#### BRADBURY PLACE TOWNHOMES A PORTION OF SECTION 3, TOWNSHIP 19N, RANGE 04 E, W.M. CITY OF PUYALLUP, PIERCE COUNTY, WASHINGTON 1 INCH = 50 FEET (22"x34")1 INCH = 100 FEET (11"x17")FOUND BRASS PIN IN CONCRETE, -SEC. 3, TWP. 19N, RGN. 4E, W.M. INCASED 1.6' DOWN AT THE NORTHWEST SEC. CORNER OF SEC. 3, TWP. 19N, RGN. 4E, W.M. VISITED 12-22-20 CALCULATED FROM ROS 30' ROAD EASEMENT AS SHOWN ON SP REC. NO.8101070262 12"PVC E IE 397.57 12"PVC W IE 397.49 12"PVC S IE 397.51 LEGAL DESCRIPTION SITE BENCH MARK 1— SET HUB AND MAG EL=406.33 (NAVD 88) PARCELS A AND B, PIERCE COUNTY LOT COMBINATION RECORDED UNDER RECORDING NO. 200104110218, RECORDS OF PIERCE COUNTY, WASHINGTON. SITUATE IN THE COUNTY OF PIERCE, STATE OF WASHINGTON. BASIS OF BEARING HELD BEARING OF SOUTH 87°44'39" EAST ALONG THE CENTER LINE OF SOUTH 96TH STREET, BETWEEN CITY OF TACOMA POINT RIM=417.44 6"PVC W/CAP DIRECTED TO CB NEAR PROPERTY LINE NUMBERS 910 AND 720. WASHINGTON STATE PLANE, NAD83/91, SOUTH ZONE CB 2 RIM=410.95 8"PVC E IE 406.55 ₹. 12"PVC N IE 406.49₹ SURVEYOR'S NOTES 1) THE MONUMENT CONTROL SHOWN FOR THIS SITE WAS ACCOMPLISHED BY FIELD TRAVERSE UTILIZING A THREE (3) SECOND THEODOLITE WITH INTEGRAL ELECTRONIC DISTA

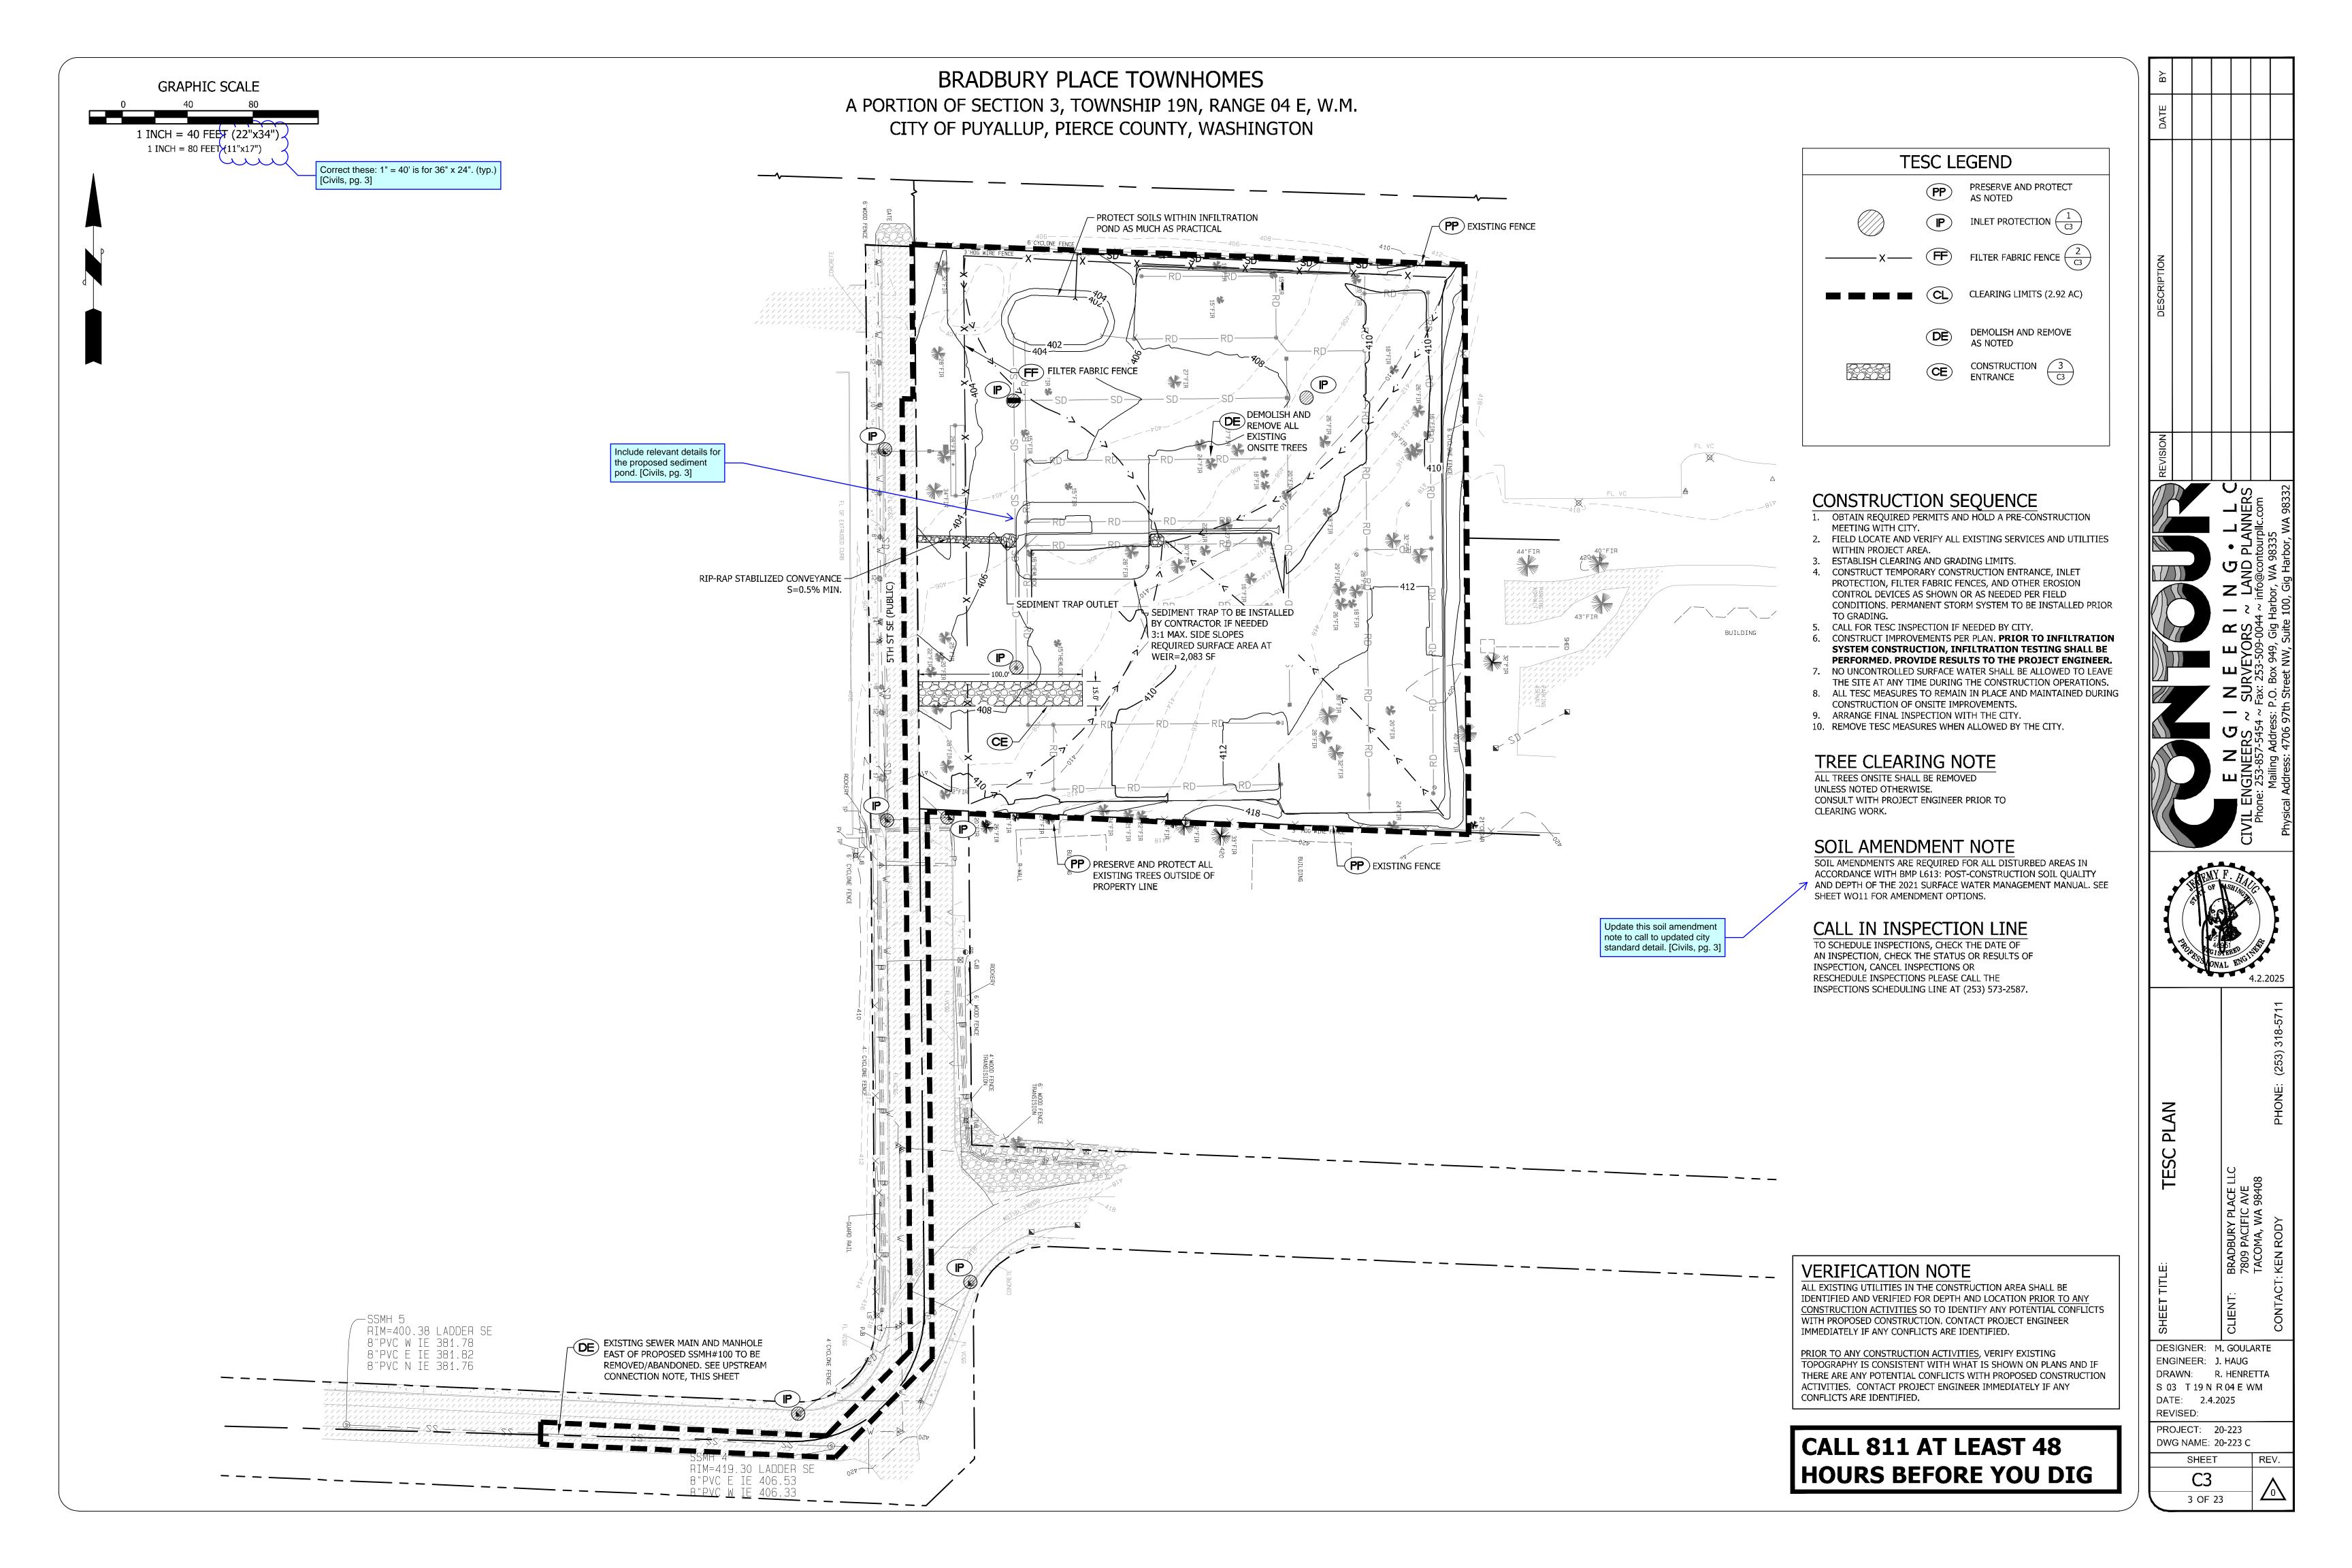
- 3. THE EROSION AND SEDIMENTATION CONTROL SYSTEM FACILITIES DEPICTED ON THESE PLANS ARE INTENDED TO BE MINIMUM REQUIREMENTS TO MEET ANTICIPATED SIN CONDITIONS. AS CONSTRUCTION PROGRESSES AND UNEXPECTED OR SEASONAL CONDITIONS DICTATE, FACILITIES WILL BE NECESSARY TO ENSURE COMPLETE SILTATION CONTROL ON THE SITE. DURING THE COURSE OF CONSTRUCTION, IT SHALL BE THE OBJIGATION AND RESPONSIBILITY OF THE PERMITTEE TO ADDRESS ANY NEW CONDITIONS THAT MAY BE CREATED BY HIS ACTIVITIES AND TO PROVIDE ADDITIONAL FACILITIES, OVER AND ABOVE THE MINIMUM REQUIREMENTS, AS MAY BE NEEDED TO P Replace with grading, erosion and AREAS, NATURAL WATER COURSES, AND/OR sedimentation control notes from section 505 STORM DRAINAGE SYSTEMS. of the city's design standards. [Civils, pg. 4]

#### Add city standard detail 05.02.01. [Civils, pg. 4]

Add the city's standard roadway notes from section 104 of the design standards. [Civils, pg. 4]

- THE PUGET SOUND LOWLANDS REGION. b. CALCULATED AMENDME Replace with City of Puyallup Standard Detail 01.02.08A ATERIAL MEETING (a.) ABOVE; OR OTHER ORG for soil amendment and depth. [Civils, pg. 4] REQUIREMENTS, AND NOT EXCEEDING THE CONTAMINANT LIMITS IDENTIFIED IN TABLE 220-B, TESTING PARAMETERS, IN WAC 173-350-220.

- 6. STORM DRAIN PIPE SHALL M Replace with stormwater notes from section 207 CIFIED ON PLANS OR BY REQUIREMENTS OF The of the city's design standards. [Civils, pg. 4]

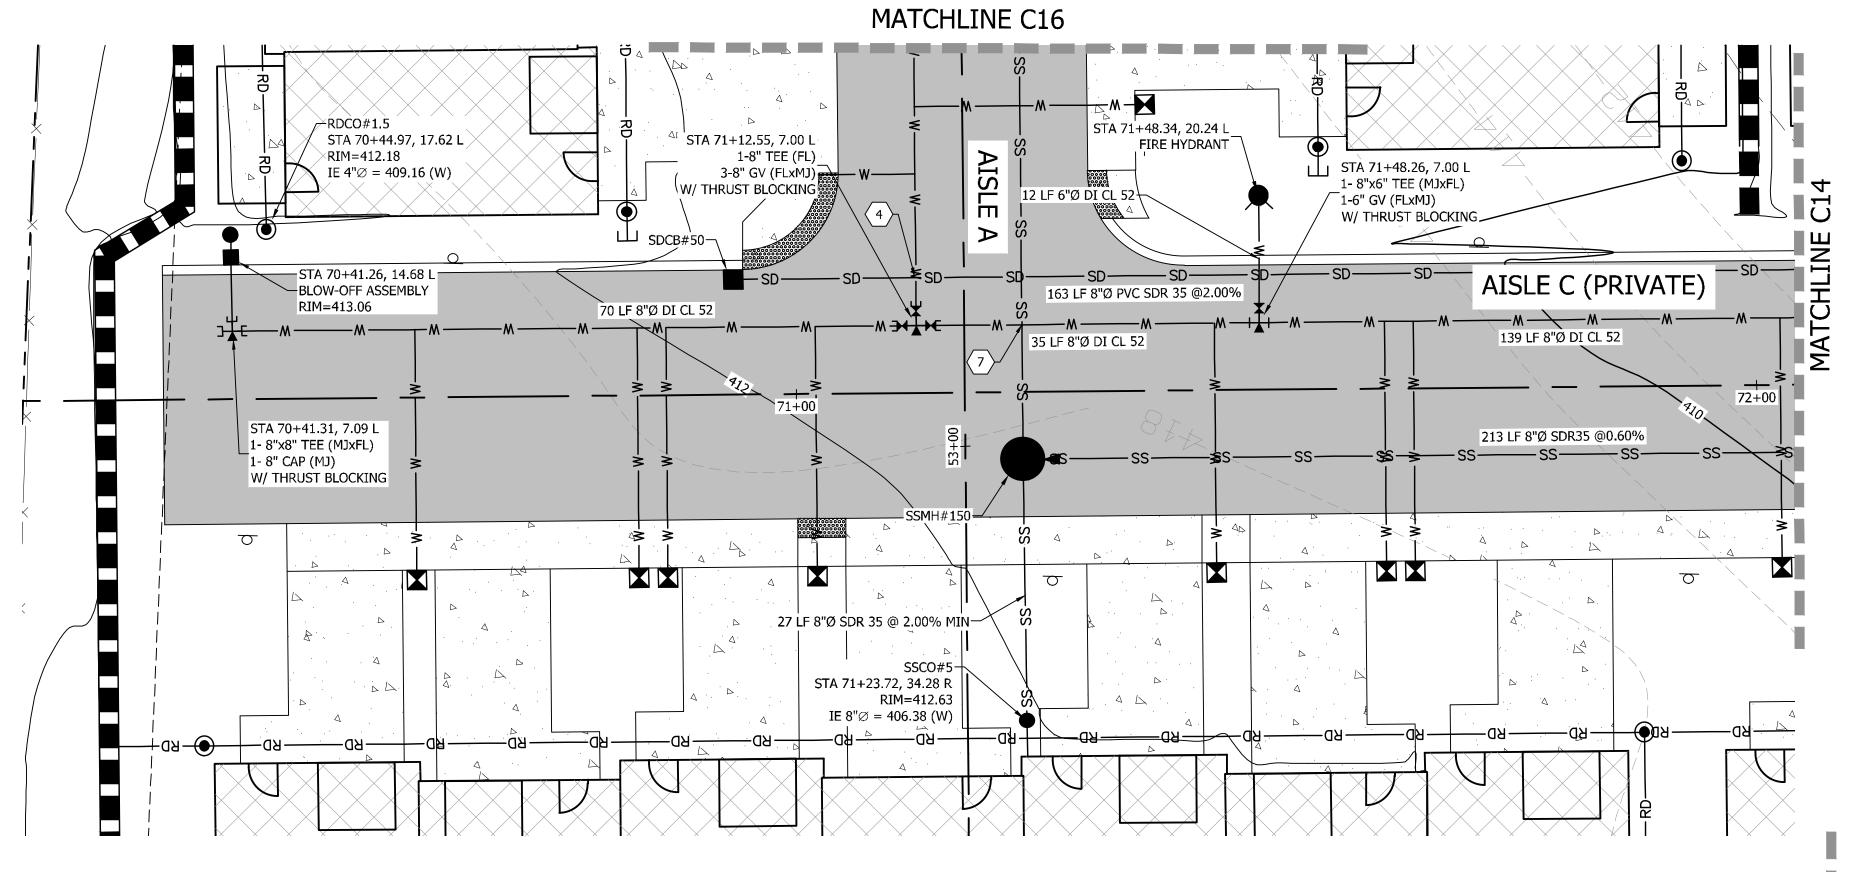
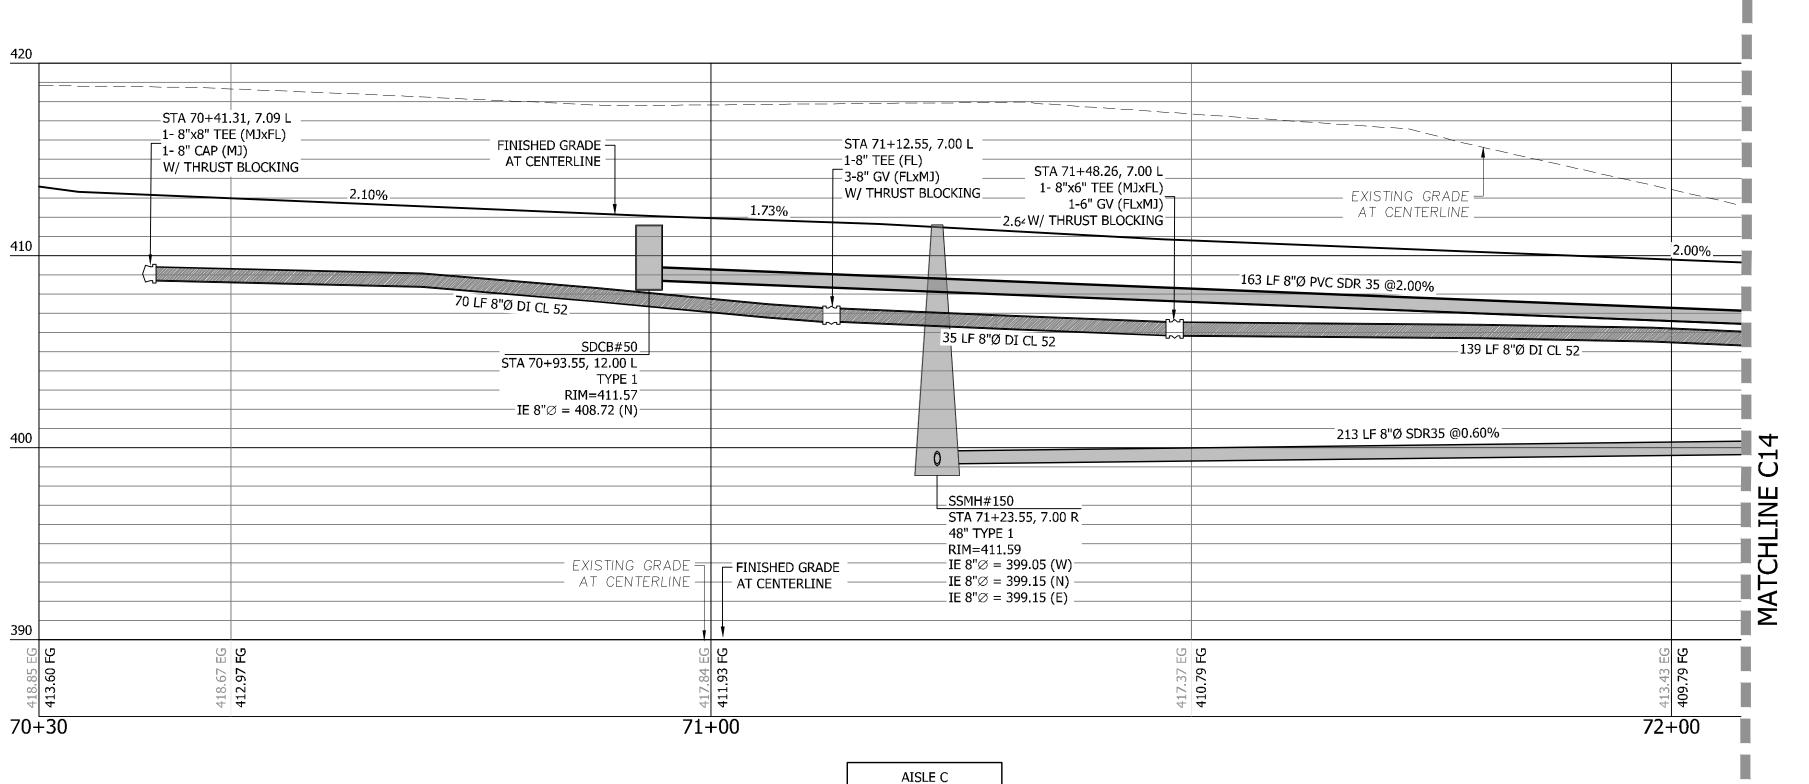
Ensure that minimum cover requirements are being met. (typ.) The minimum allowed cover for PVC is 3-feet. Alternatively, ductile iron is an allowed pipe material that only requires 1-foot of cover. [Civils, pg. 13]

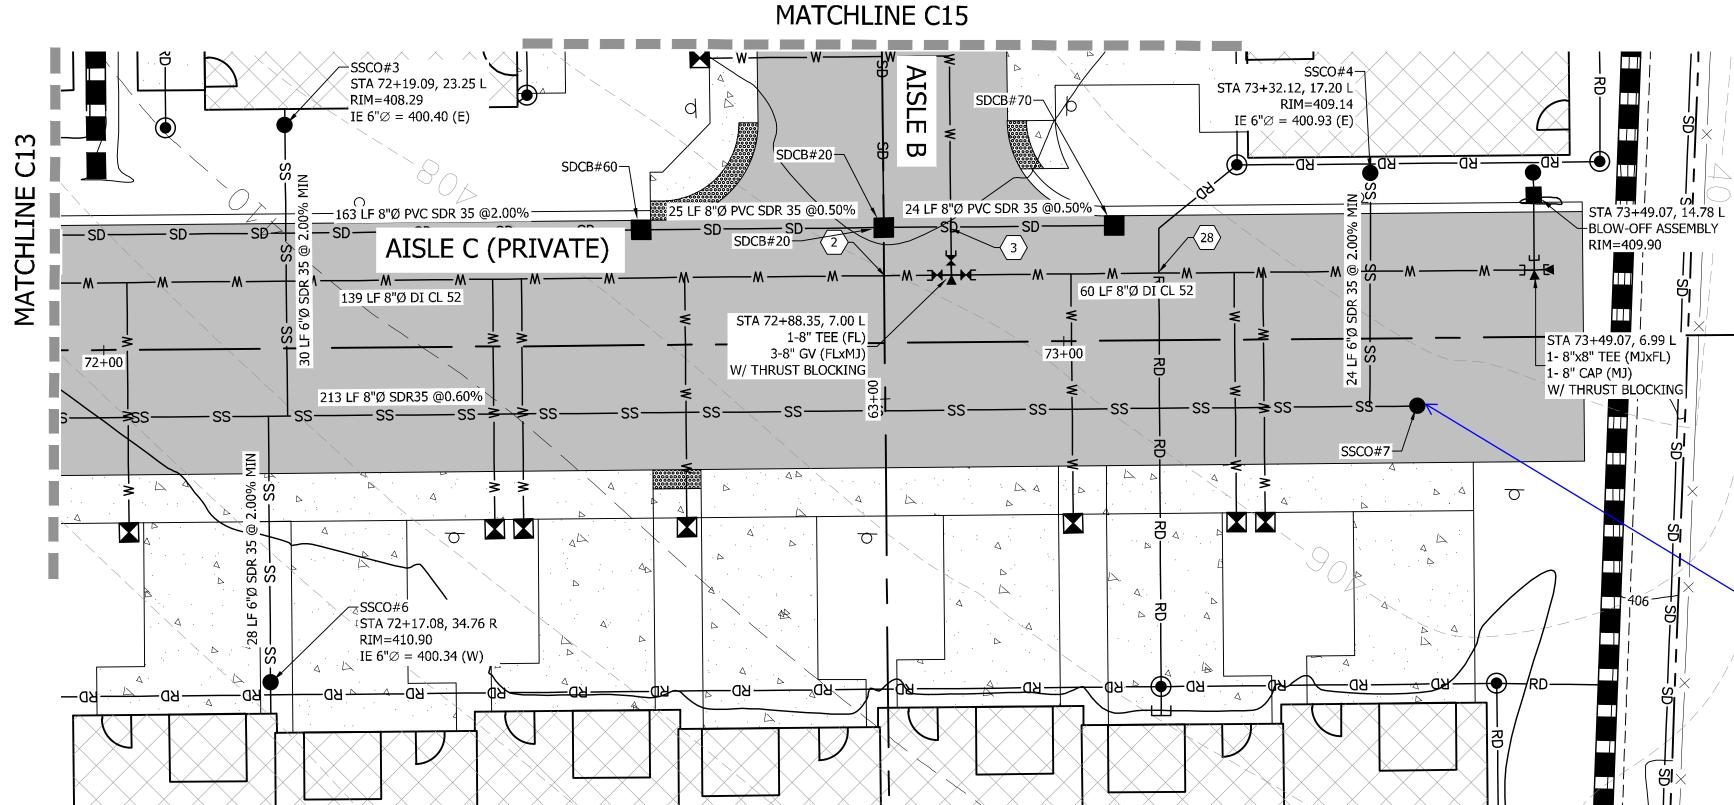
Sewer runs need to terminate with a manhole rather than a cleanout. [Civils, pg. 14]
